Subject: VLO-24-02 44 E. Flint, Site Plan Review #1

Re: 44 E. Flint Street
Site Plan Review
NFE Job No. N930

To: Darwin McClary, Village Manager
From: Jeff Williams, Fire Marshal
Re: 44 E. Flint – Commercial / Multi Family Development
Date: 5/15/2024

TOPOGRAPHIC SURVEY

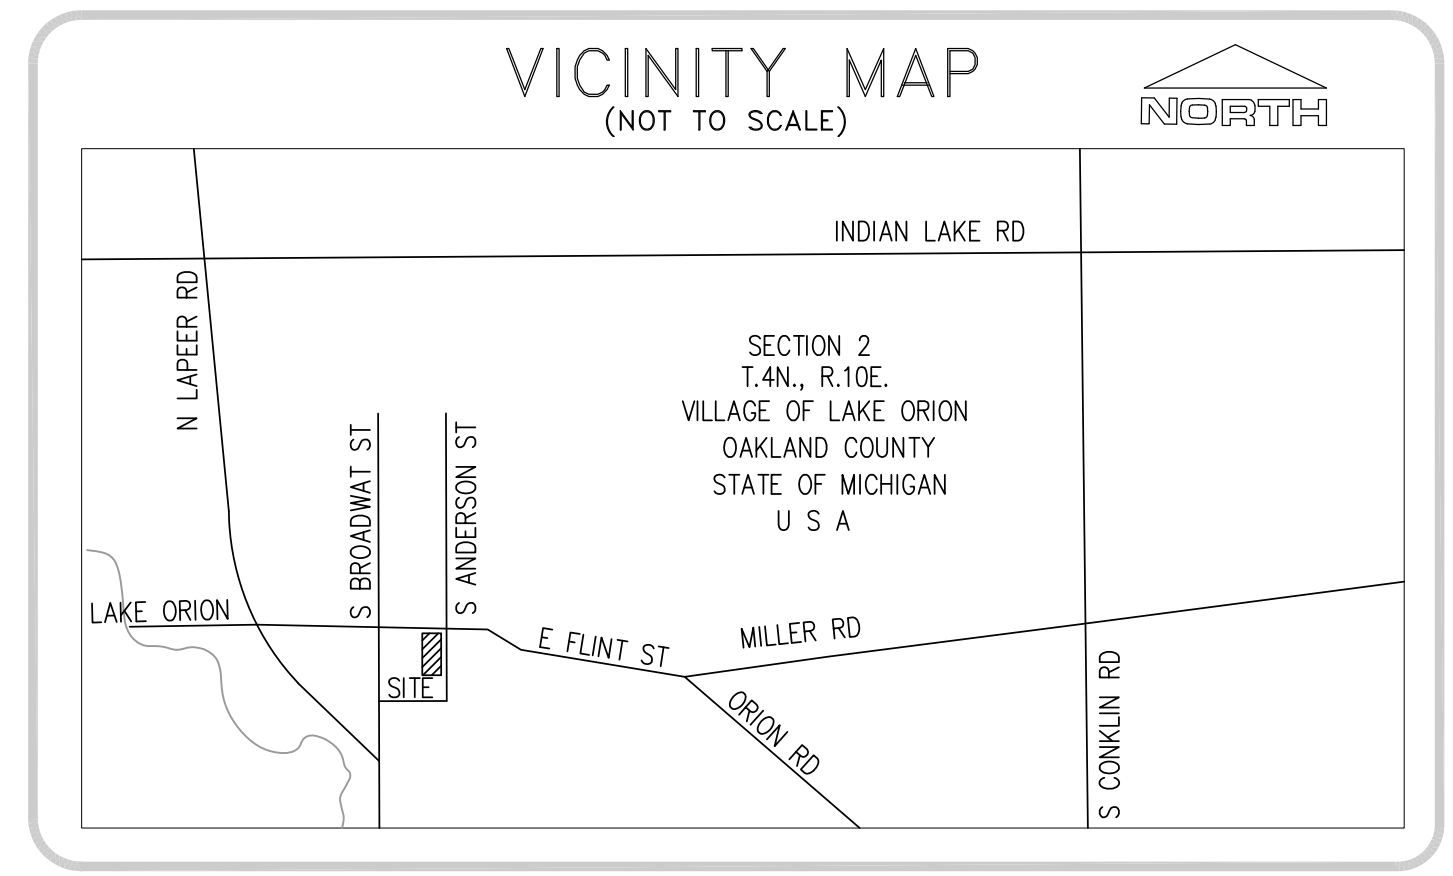
1. The Site plan must be prepared superimposed on the topographic information, indicating the property lines (with bearings and distances), all existing easements, and all existing and proposed utilities.

15. It must be demonstrated that adequate fire hydrant protection can be provided for the proposed building. Show nearest hydrants.
16. Expand topographic survey to show features to 100' beyond the site boundary per Article 19 requirements. Show existing screen wall along east property line. Show zoning of adjacent parcels, including across rights-of-way.

44 E FLINT
PHOTOMETRIC LAYOUT
GASSER BUSH ASSOCIATES
WWW.GASSERBUSH.COM

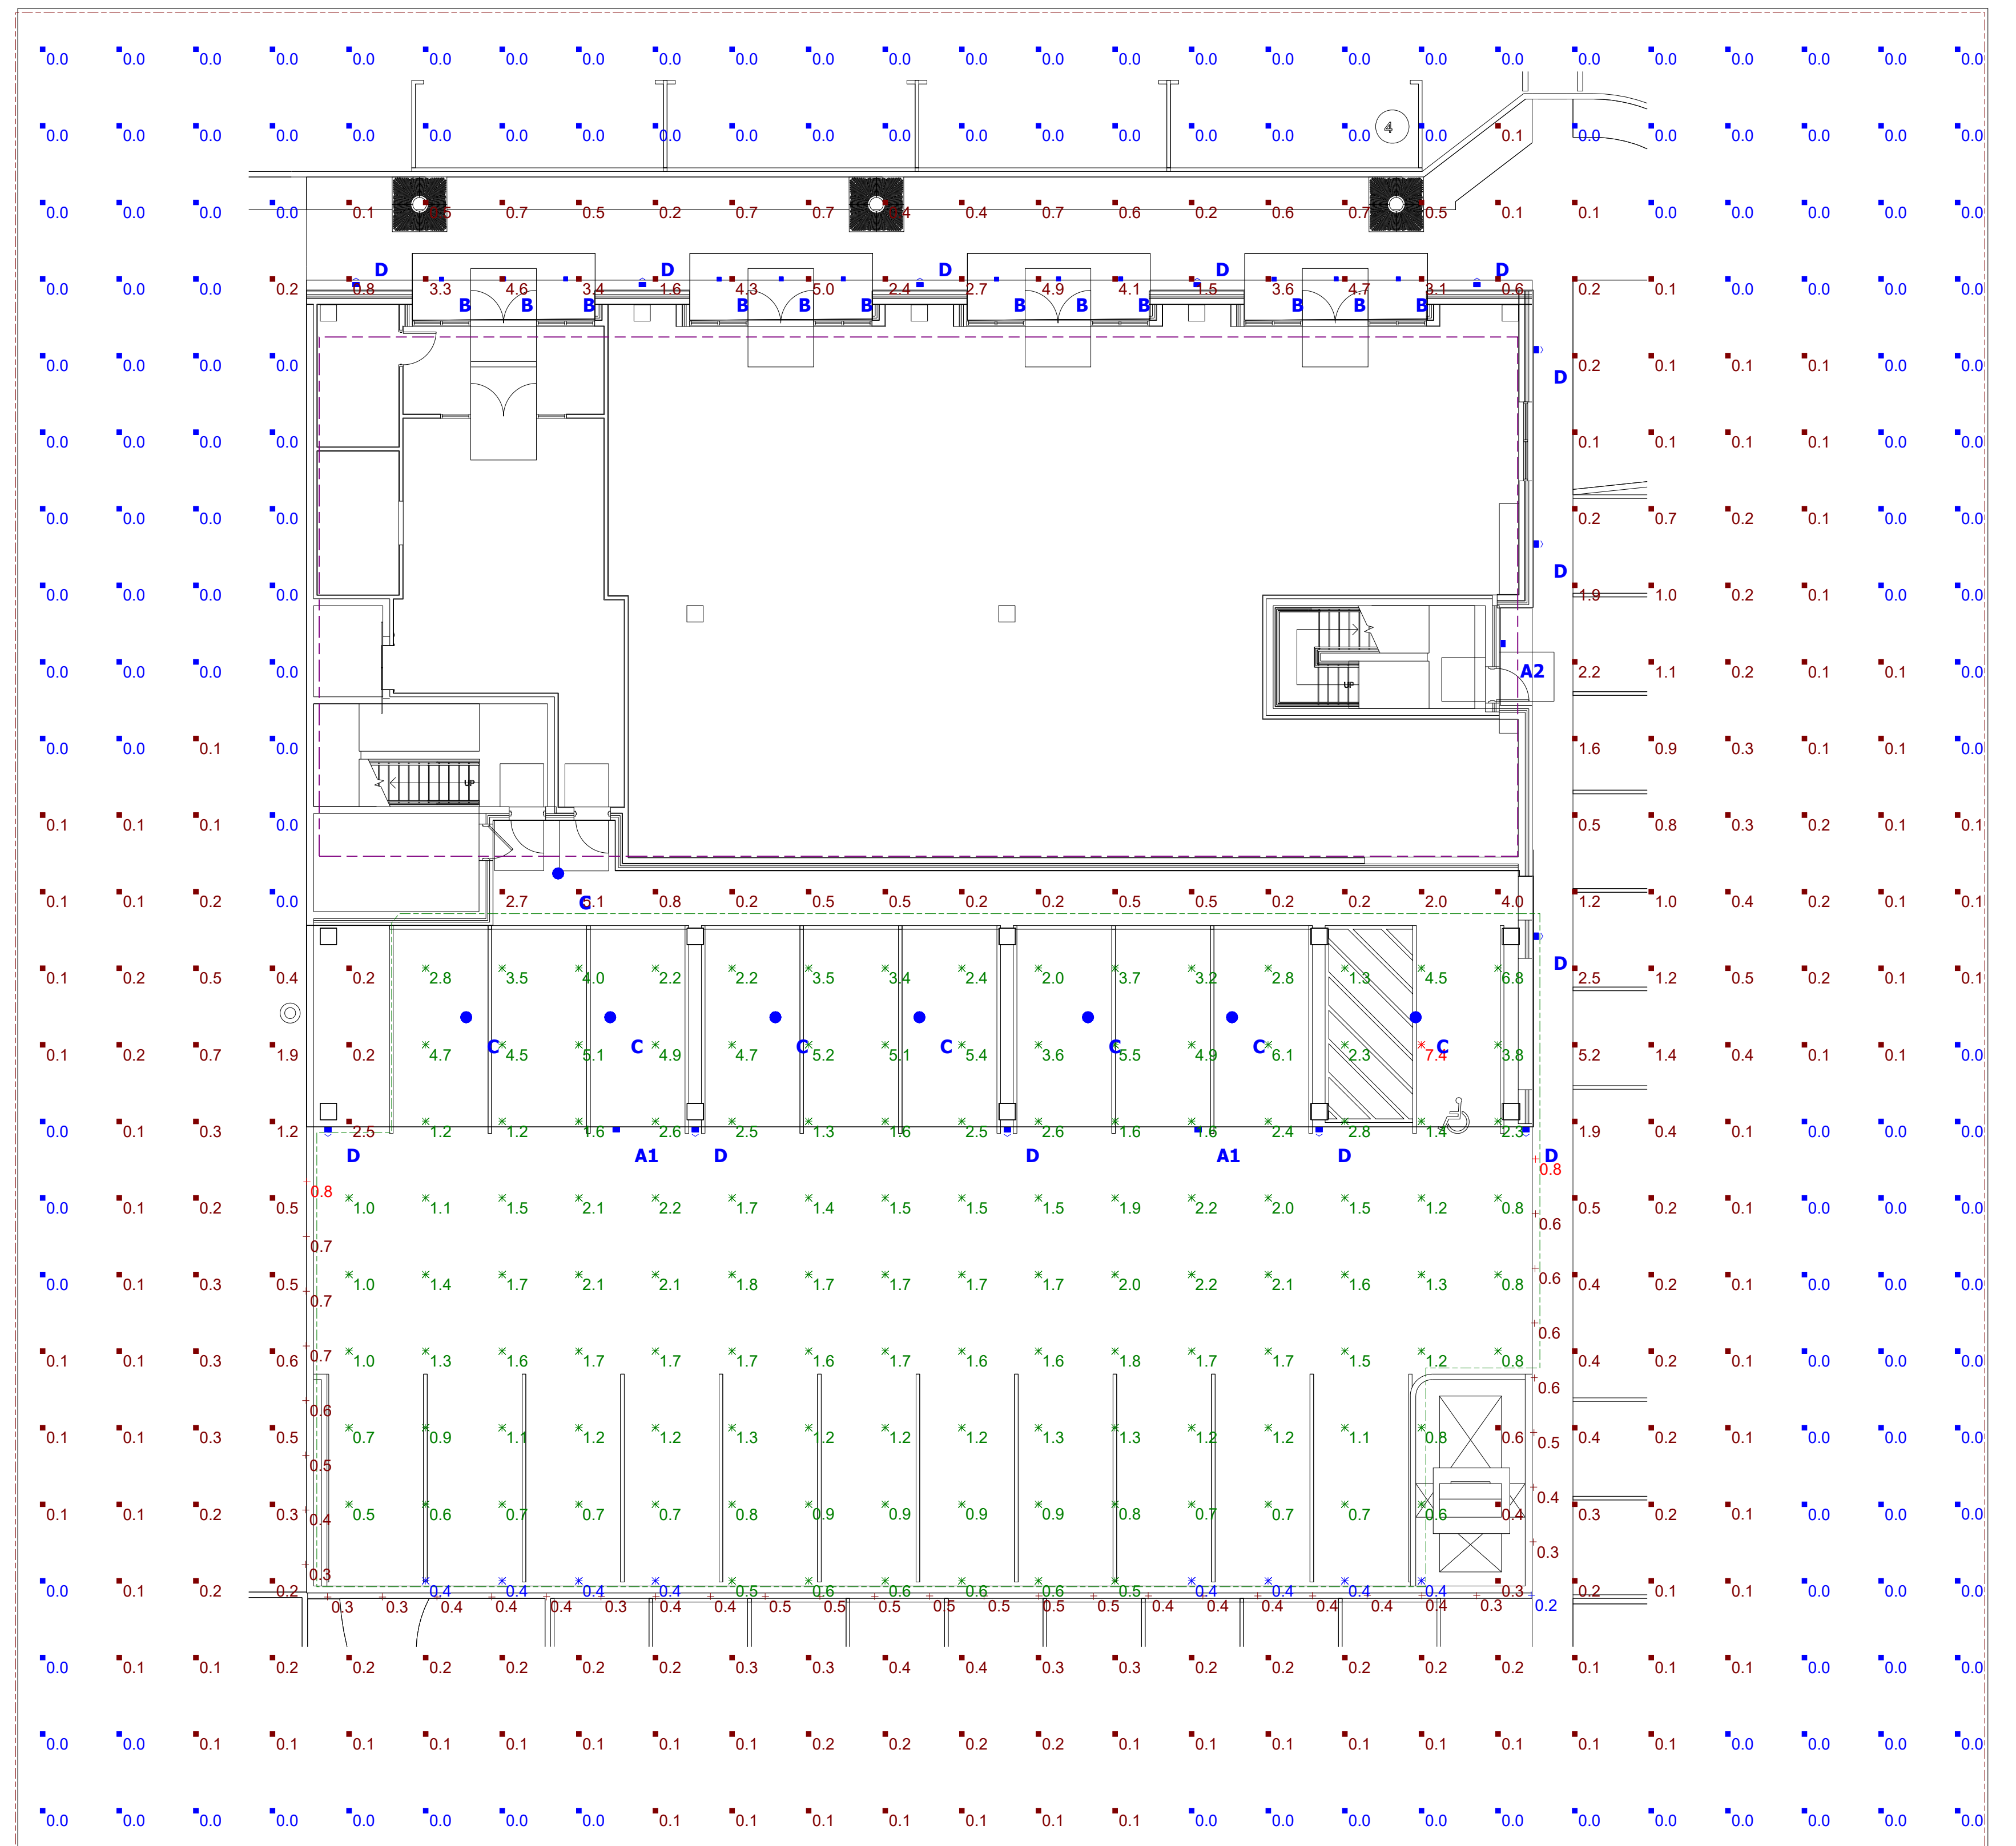
- d. **Lighting.** Fixtures should be harmonious with the existing street lighting. The proposed sconce lighting is very sleek and relatively large; we recommend more traditional fixtures such as gooseneck or lantern-type lighting to complement the historic character of the area.

Findings: Both building-mounted and freestanding pole lighting are proposed for the development; a photometric plan and fixture cut sheets have been provided. Illumination requirements are as follows:

Lighting Category	Standard	Proposed	Comments
Max. Height of Fixtures	22 ft.	<u>Unknown</u>	<u>May Comply: mounting height not specified.</u>
Max. Illumination at Any Given Point	10 fc.	7.4 fc.	Complies.
Max. Illumination at the Property Line	0.5 fc.	<u>0.8 fc.</u>	<u>Can Comply: reduction and waiver required.</u>

The Planning Commission may modify lighting requirements in considering possible off-site impacts and the character of the proposed use. We recommend that the lighting along Anderson be reduced, to minimize off-site impacts. We recommend the Planning Commission grant a waiver for proposed illumination along Flint.
